Document: TI_F421_006_HALO_homologation_label_and_hologram

Subject: HALO homologation label and hologram

Table	Item	Part number
01-D	4	2401009

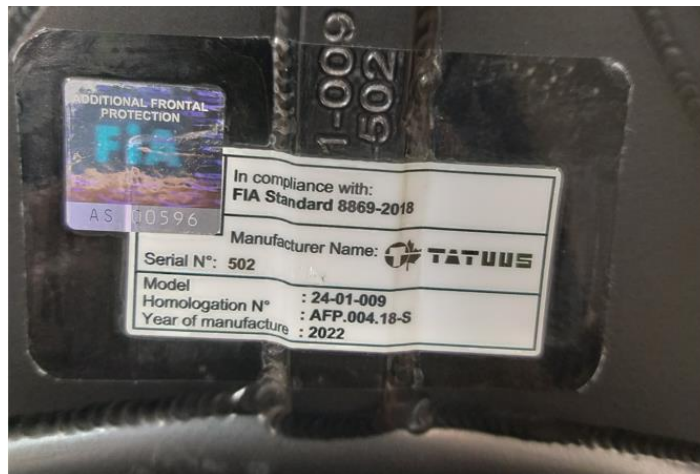
By FIA requirement the HALO must be marked with an FIA homologation label and FIA hologram. Both the label and the hologram must only be fitted by Tatuus.

The homologation label and the hologram must be visible, they cannot be covered by wrapping or paint. It is suggested to protect the homologation label and the hologram with a transparent film (i.e., helicopter tape). Please find in the picture below an example of the label and hologram fitted on the HALO, protected with 3M 8672 Tape
